ENERGY

WITH COMMENTS

Proposed Code Modifications

Sub Code: Energy Conservation

Figure 2 Average Florida home savings resulting from Florida Energy Code implementation.

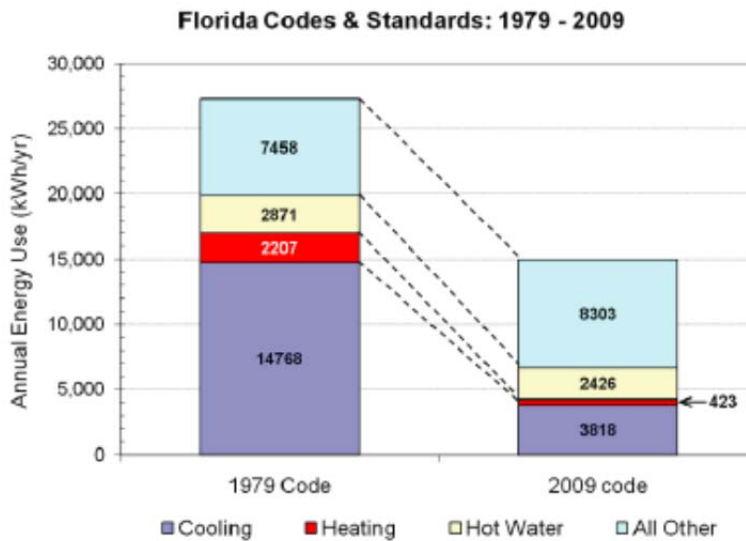
d.) **e-Ratio**. Using the e-ratio inflates the energy savings in a home. The code change proposal uses the Energy Performance Index (EPI or e-ratio) as justification. The e-Ratio is not an indication of the total loads on the home. It is defined by FSEC¹ as including only the heating, cooling, and domestic hot water loads. Analyses performed using Energy Gauge and other programs show that this load is less than half the energy load of the home. See also Figure 2 in another FSEC report², reprinted below. The light blue is all other loads; these are larger than heating, cooling, and hot water loads combined. **The energy savings in a home using an e-Ratio is inflated to about twice of that shown using total loads.** This is further demonstrated below.

More energy savings can be found from reducing these other loads (lighting, appliances, and plug loads) than the loads in the e Ratio.

Figure 2 Average Florida home savings resulting from Florida Energy Code implementation.

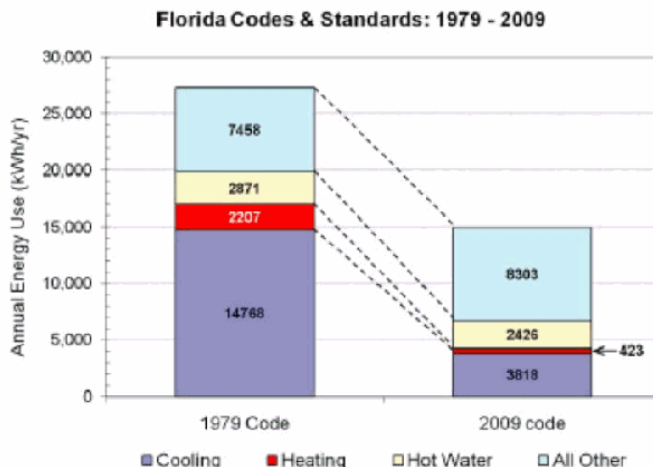
a.) **e-Ratio.** Using the e-ratio inflates the energy savings in a home. The code change proposal uses the Energy Performance Index (EPI or e-ratio) as justification. The e-Ratio is not an indication of the total loads on the home. It is defined by FSEC¹ as including only the heating, cooling, and domestic hot water loads. Analyses performed using Energy Gauge and other programs show that this load is less than half the energy load of the home. See also Figure 2 in another FSEC report², reprinted below. The light blue is all other loads; these are larger than heating, cooling, and hot water loads combined. **The energy savings in a home using an e-Ratio is inflated to about twice of that shown using total loads.** This is further demonstrated below.

More energy savings can be found from reducing these other loads (lighting, appliances, and plug loads) than the loads in the e Ratio.

Figure 2 Average Florida home savings resulting from Florida Energy Code implementation.

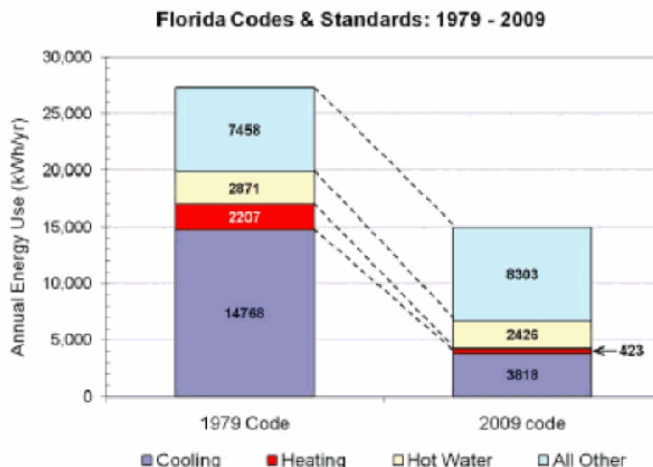
a.) **e-Ratio.** Using the e-ratio inflates the energy savings in a home. The code change proposal uses the Energy Performance Index (EPI or e-ratio) as justification. The e-Ratio is not an indication of the total loads on the home. It is defined by FSEC¹ as including only the heating, cooling, and domestic hot water loads. Analyses performed using Energy Gauge and other programs show that this load is less than half the energy load of the home. See also Figure 2 in another FSEC report², reprinted below. The light blue is all other loads; these are larger than heating, cooling, and hot water loads combined. **The energy savings in a home using an e-Ratio is inflated to about twice of that shown using total loads.** This is further demonstrated below.

More energy savings can be found from reducing these other loads (lighting, appliances, and plug loads) than the loads in the e Ratio.

Figure 2 Average Florida home savings resulting from Florida Energy Code implementation.

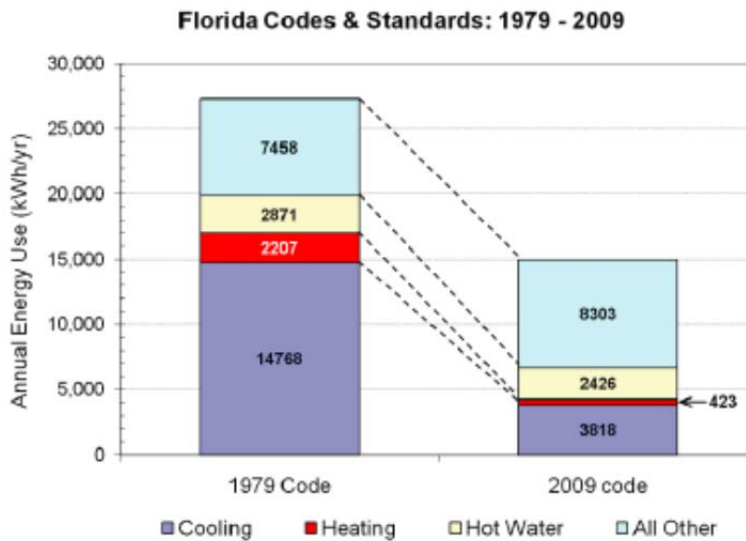
d.) **e-Ratio**. Using the e-ratio inflates the energy savings in a home. The code change proposal uses the Energy Performance Index (EPI or e-ratio) as justification. The e-Ratio is not an indication of the total loads on the home. It is defined by FSEC¹ as including only the heating, cooling, and domestic hot water loads. Analyses performed using Energy Gauge and other programs show that this load is less than half the energy load of the home. See also Figure 2 in another FSEC report², reprinted below. The light blue is all other loads; these are larger than heating, cooling, and hot water loads combined. **The energy savings in a home using an e-Ratio is inflated to about twice of that shown using total loads.** This is further demonstrated below.

More energy savings can be found from reducing these other loads (lighting, appliances, and plug loads) than the loads in the e Ratio.
